**CITY COUNCIL
PLANNING AND PROPERTY
COMMITTEE REPORT**

RE: Kenora Patricia Child & Family Services – Birchcliff Group Home Site Plan Control

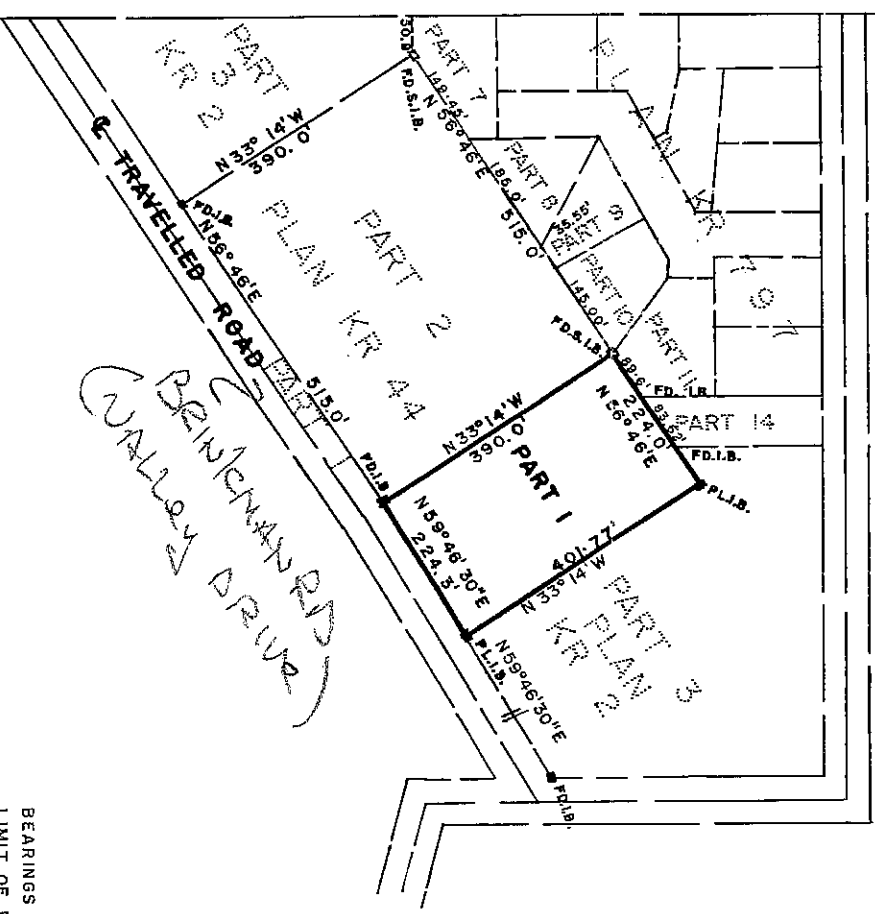
The proponent provided a response to the City's concerns and City Staff are satisfied that all issues have been addressed adequately. The agreement will include a statement that the sidewalk to be re-constructed, must be to City standard, and a statement that the detail (for curb cuts) on details #7 & # 8 on drawing A1.3 applies only to the works on private property.
